Board of Supervisors

Appeal of Planning Commission's Approval of a Design Review Permit for the West County Transportation Agency's Phase II Bus Storage Yard with Bus Driver Parking

3300 Juniper Avenue

DRH22-0008

Phase II Site Plan/Landscape Plan

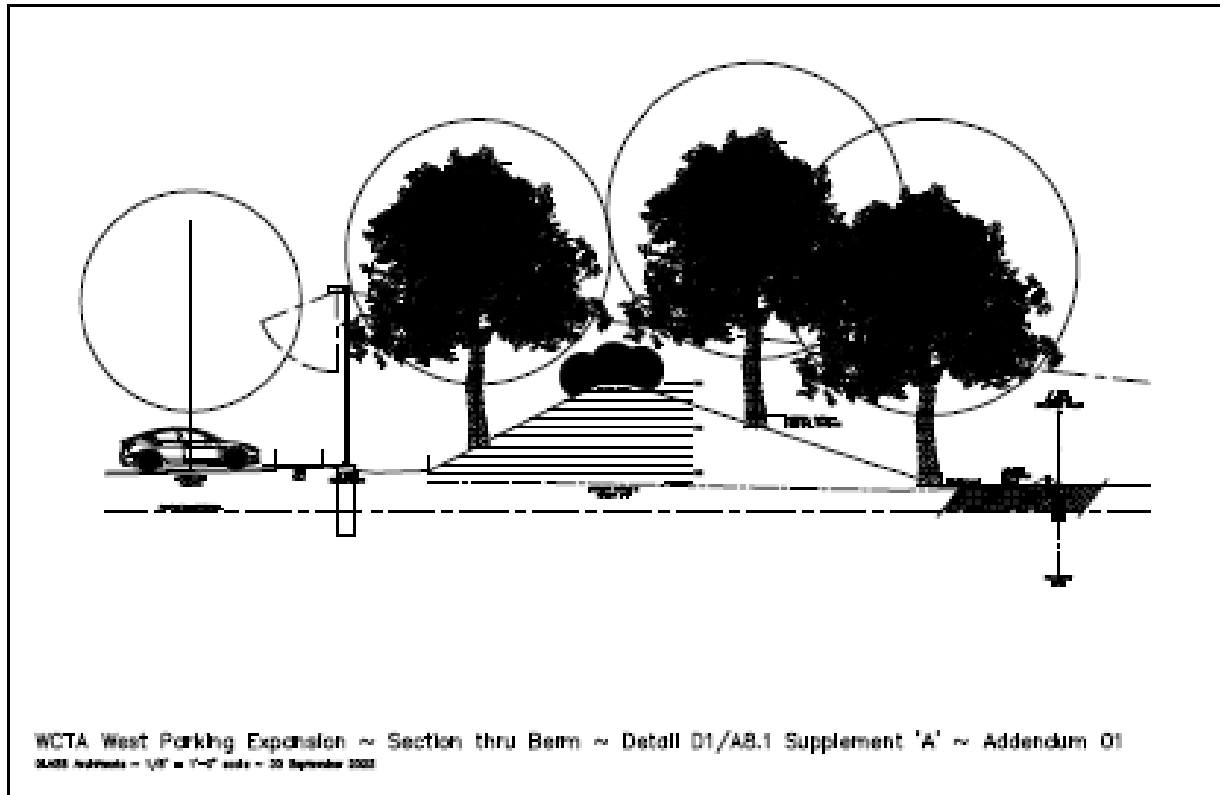
- Determined that Phase II was consistent with 1999 COA, including 80 bus parking spaces and 80 bus driver parking spaces.
- DRC Approval:
 - Plant additional trees along north berm and at northeast corner of site;
 - Include shrub planting along the berm at northeast corner;
 - Open wire security fencing ok on property line.
 - Lower light fixtures in employee parking area from 27 feet to 14 feet.
 - Lower light fixtures in bus parking area from 30-35 feet to 16 feet.
 - Lower color temperature of lights from 3000 to 2700 degrees Kelvin.
 - Auto dimming on all lights and power shut off on employee parking side.

Updated Approved Phase II Site Plan

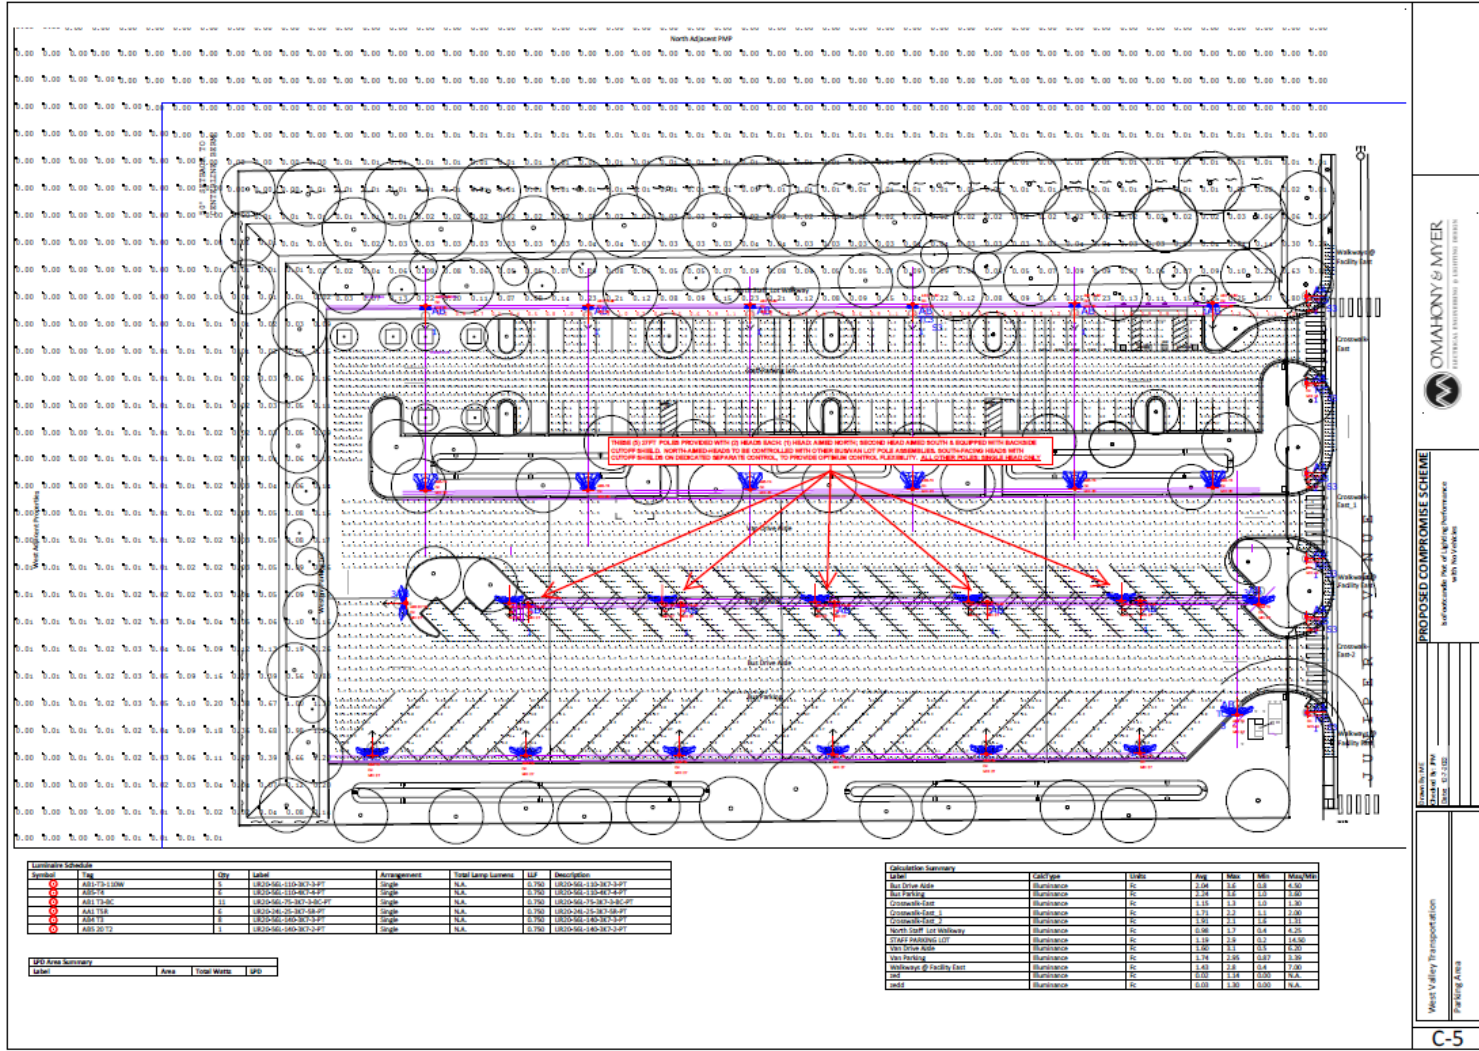
- Applicant Response:
 - a. Updated Phase II site plan reduced bus parking on Phase II from 80 to 71 spaces
 - b. Confirmed site lighting in bus driver parking area would be shut off from 6 pm to 6 am.
 - c. Provided additional documentation on fencing, lighting and drainage

- Wire fencing at property lines, except Juniper Avenue/no slats except on south property line. Remove crossbar if feasible.
- Lighting approved in bus driver parking at 20' in height to be shut off from 6 p.m. to 6 a.m.
- Lighting approved in bus parking at 27' in height using motion activated fixtures. Lower lights if feasible.
- Lighting cut-offs and back shields required.

Lighting Photo Metrics

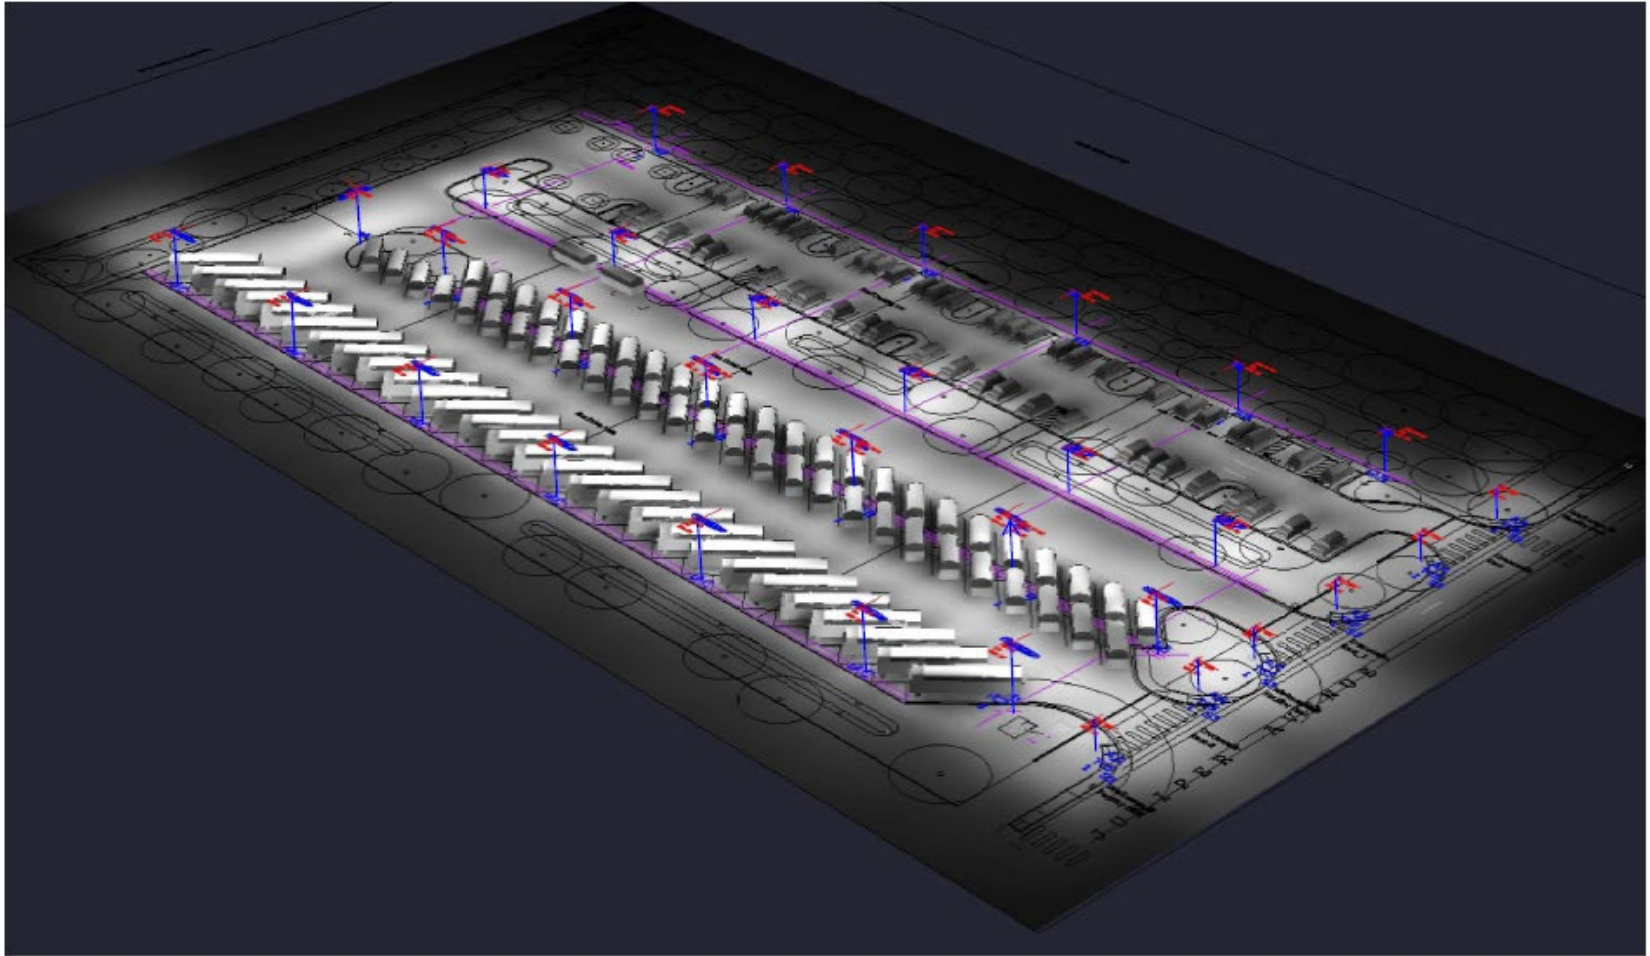
7. Lighting violates lighting restrictions pursuant to Condition 46 because only security lighting is permitted and may only be located at the periphery.
 - *All proposed lighting is for security of bus drivers or buses parked overnight. No flood lights are proposed and all lighting is required to have cut-offs and back shields. Lighting is designed to be internal and avoid lighting beyond the property lines. Bus driver parking would be shut off from 6 pm to 6 am and bus security lighting is limited to 5 motion activated fixtures at maximum 1 candle power.*
